Service information

Reference no.: SDA_114084

Slipping off water sensor wiring

Code:
New wiring: 421946035161 3P.CONN.WATER LEVEL V2 SMR UL ASSY

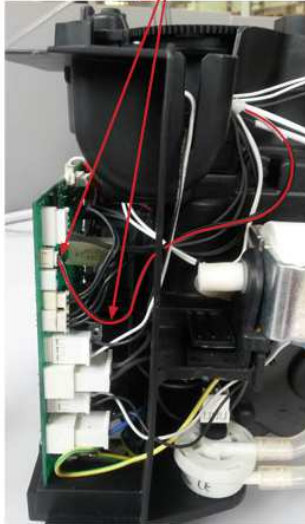
Symptom:
Alarm for empty water tank remains always on.

CURE:
Wiring was improved to avoid that the plug of water level sensor is disconnecting from CPU board.

Actions:
In case the plug was disconnected, replace the plug by the improved version and refit it proceed as shown in following images.

Insert the ring of the wiring on the plate. Block wiring with silicone tube.

Pass the wiring in the window (low voltage) connect to the PCBA. Arrange wiring and check that it is not tensed.

Connect to the water level sensor Pass the wiring of the hooks In the picture to see the position of the clamp.
